Hydrol. Earth Syst. Sci. Discuss., author comment AC1
<https://doi.org/10.5194/hess-2021-5-AC1>, 2021
© Author(s) 2021. This work is distributed under
the Creative Commons Attribution 4.0 License.

Reply on RC1

Author comment on "Drought-induced non-stationarity in the rainfall-runoff relationship invalidates the role of control catchment at the Red Hill paired-catchment experimental site" by Yunfan Zhang et al., Hydrol. Earth Syst. Sci. Discuss.,
<https://doi.org/10.5194/hess-2021-5-AC1>, 2021

Response to Reviewer #1

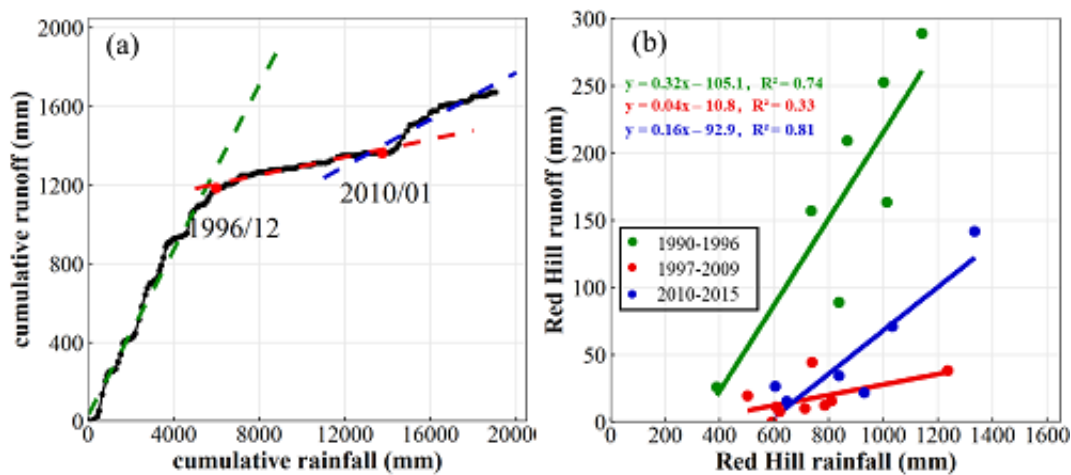
- It's a flaw that the manuscript lacked detection of changes in the rainfall-runoff relationship for the treated catchment. Although it's obvious why there is a control and a treated catchment, I think it's important to apply the appropriate parts of the applied analysis for the treated catchment, also to have a better understanding of the underlying processes; to confirm or to deny the non-linear behaviour of the treated catchment.

A. If the treated catchment has not been reforested, did you expect the treated catchment to show similar behaviour as the control catchment?

B. Does the treated catchment already shows the same non-linearity as the control catchment?

A. If the treated catchment has not been reforested, we expect the treated catchment to show similar behaviour as the control catchment. Because the terrain, meteorology, area of the two catchments are very similar, when the treated catchment is not reforested, the land cover types of the two catchments are also similar, both are grassland. When prolonged drought occurs, the change of hydrological process in two catchments should be similar.

B. Yes, the treated catchment shows the similar non-linearity as the control catchment, as shown in Figure R1 and Figure 5 (Page 39). But observed changes in treated catchment should be driven by two factors, i.e. afforestation and prolonged drought by assuming prolonged drought can lead to changes in rainfall-runoff relationship of the treated catchment.

Figure R2 The variation in monthly rainfall of the Kileys Run catchment (control catchment), New South Wales, Australia, during the periods of 1990–2015.

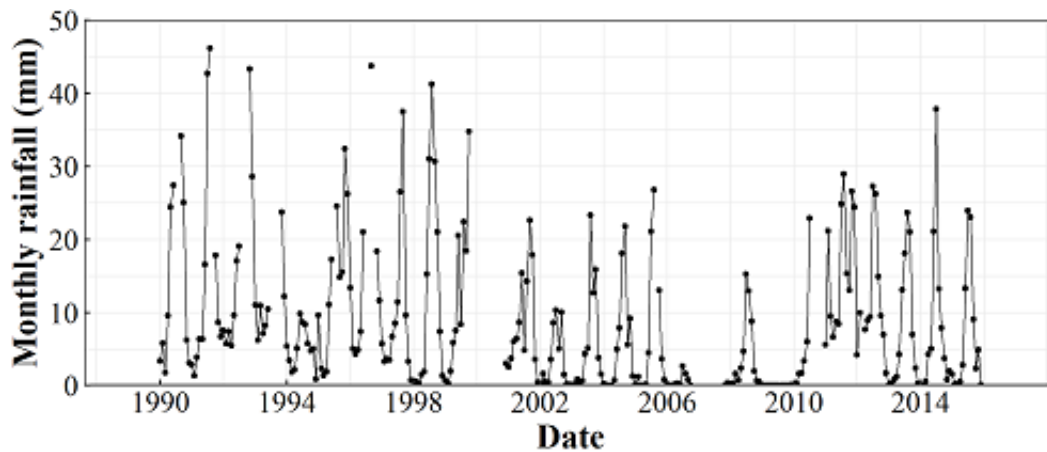
- Lines 139-147; what is the variation in monthly rainfall? Seasonal? What Köppen climate?

The variation in monthly rainfall can be seen in Figure R2. Seasonal changes in monthly rainfall can be seen in Figure R3. The monthly rainfall decreased greatly during the period of 2001-2009 and increased after 2010, but is still less than the monthly rainfall before 2001. There is more precipitation in winter (June, July and August), but the difference amongst rainfall of four seasons is small. The climate type in Kileys Run and Red Hill

Figure R4. (a) Monthly runoff at control (Kileys Run) vs. treated (Red Hill) catchments in New South Wales, Australia, during the calibration period, and (b) Monthly rainfall vs. runoff of the treated catchment during the calibration period. Dashed line is the 1:1 line.

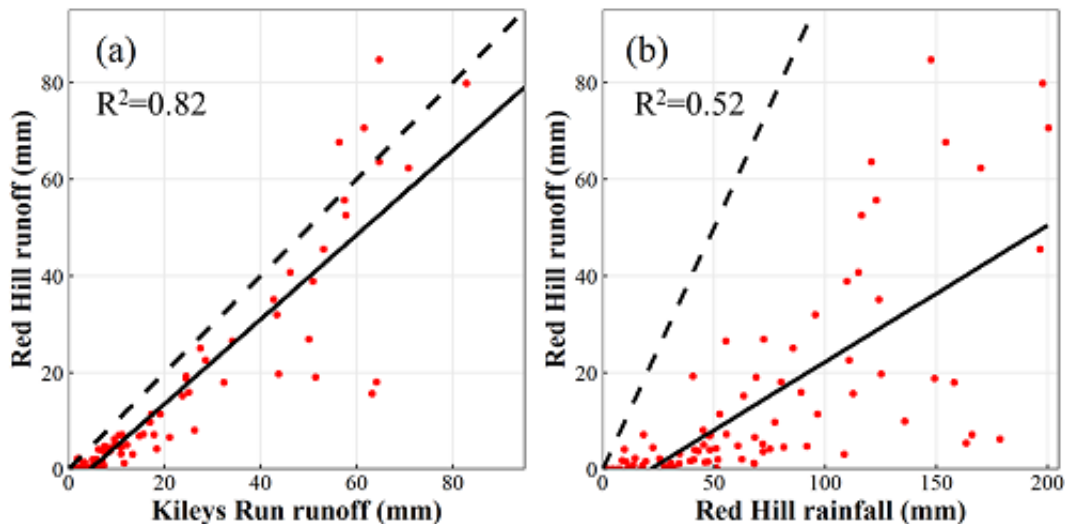
- Figure 4. A. The left figure is Kileys Run, but in the caption you mention Red Hill first, change either the caption or the figure order. B. The x- and y-axis do have different ranges, this makes the graphs difficult to compare and to understand the meaning of the results.

Reply: Thanks for your helpful suggestions. Figure 4 will be replaced by Figure R4 in revised manuscript as follows:

A. The title of Figure 4 has been changed to that of Figure R4.

B. The runoff-runoff relationship for the two paired catchments in Figure 4 (a) is used in the paired catchment method, and the rainfall-runoff relationship of the treated catchment in Figure 4 (b) is used in the time-trend analysis method.

Figure R5. Daily flow duration curves of the Kileys Run catchment (i.e., control catchment), New South Wales, Australia, over four different periods (see legend).

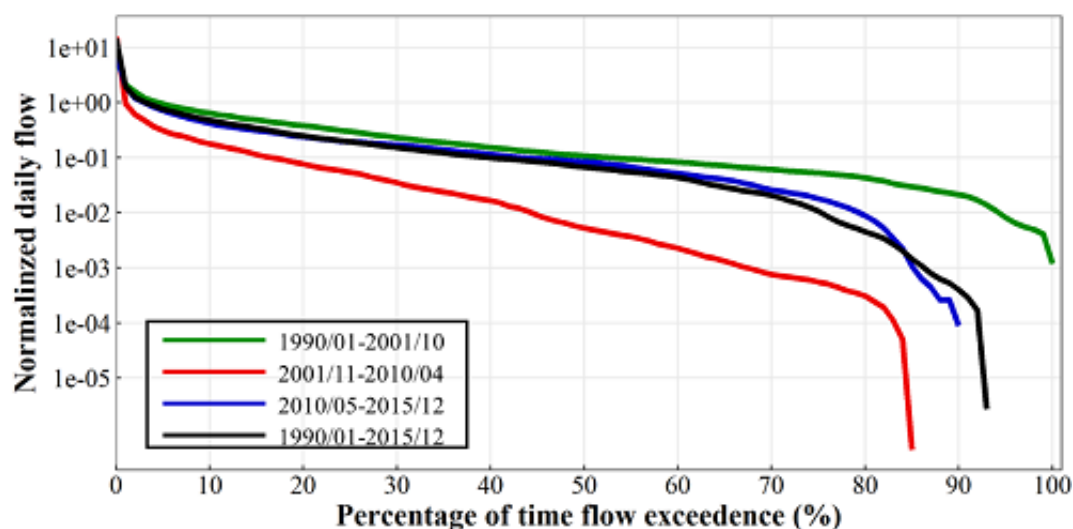
- Figure 6; you may consider add the daily flow duration curve for the entire measurement period (1990-2015) to indicate the differences;

Reply: Thanks for your helpful suggestions. The daily flow duration curve including the entire measurement period (1990-2015) can be seen in Figure R5.

The FDC of the entire measurement period (1990-2015) is close to the FDC of the third period (2010-2015). There is 6% no-flow days during the whole period. In the first period (pre-drought), the second period (after drought) and the whole period (including the whole drought period), high flows have a highly consistent change, but the difference amongst low flows is significant. It indicates that the impact of prolonged drought on the low flow is more serious than that of the high flow. When the rainfall increases, the high flow may recover quickly, but the low flow may recover slowly.

Figure R6. Estimated monthly values of parameters (a) C and (b) SC used in the two-parameter monthly water balance model for the Kileys Run catchment (control catchment), New South Wales, Australia, during the period of 1990–2015.

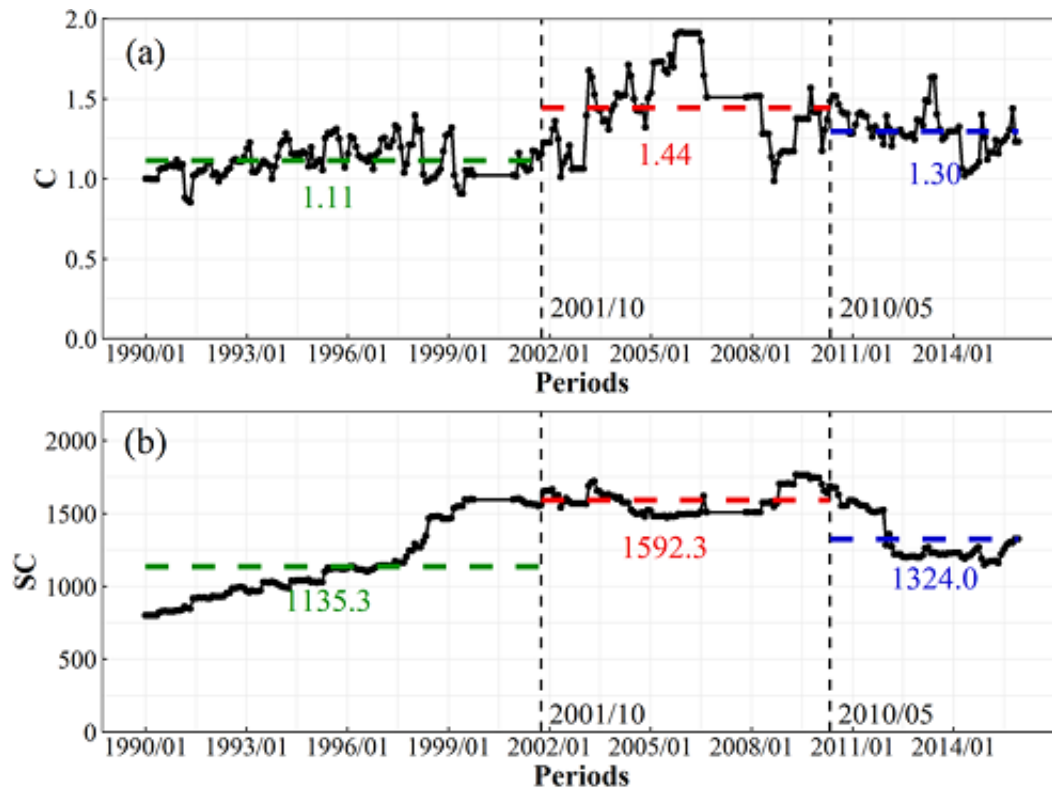
- Figure 7; The x-axis of the graphs could be better aligned;

Reply: Thanks for your helpful suggestions. Figure 7 will be replaced by Figure R6.
